Week 9:

**Date:** 10/21/2021

## Midterm Review

Fig. 1 The completed PCB without any errors

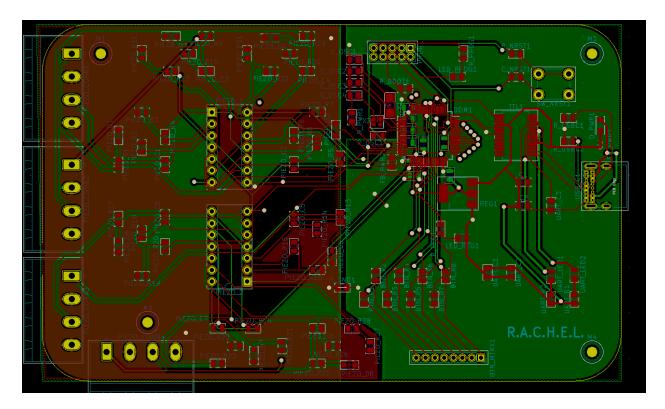
The most criticism we got was for our PCB and overlooking how difficult a mounting rig for camera/projector imposes. The PCB had a large of problems:

- Ground plate below clock oscillators
- 2) No extra Front layer ground plate on the analog side
- 3) Incorrect diode footprint for the SOD-323
- 4) Decoupling caps were far from the microcontroller and power
- 5) USB-C could not be plugged in "upside-down" because of no cross wiring of the connector

Attached below in Fig. 1, is the PCB with all of its fixes. I also doubled the trace thickness for the 5V traces. Which may not be necessary These fixes were enough for nothing to be added for the review and we proceeded with ordering the PCB. However, we still need to order the button matrix PCB if it hasn't been done so already by Jack.
